**Attachment 2**  
**Atmospheric Relief Valve Area**  
**Heatup Calculations**

Devonrue Calculation Cover Sheet

Subject: ARV Area Ambient Temperature Rise During SBO

**Subject: Ginna Atmospheric Relief Valve (ARV) Area Ambient Temperature Rise - Revised Methodology**

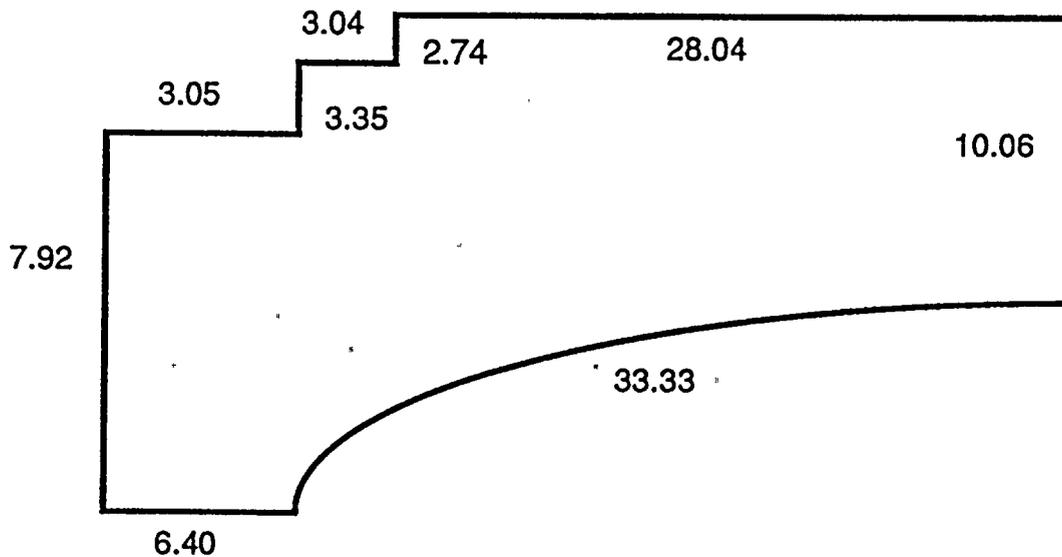
<sup>2</sup> Reviewer's note: a review of the drawing shows that the containment wall represented by the curved line in the figure actually extends upward farther than indicated. Thus, the 28.04x10.06 rectangle takes credit for some area that is actually in the containment rather than in the intermediate building. When this is accounted for, the ARV ceiling area is approximately 244 square meters.

Use of a larger ceiling area should not significantly affect the ceiling temperature determined later in this calculation. A corrected ceiling area of 244 square meters is used in the final room temperature where use of a larger area would be nonconservative.

<sup>4</sup> Reviewer's note: the corrected total wall areas are used for the remaining calculations, as discussed in footnote 2.
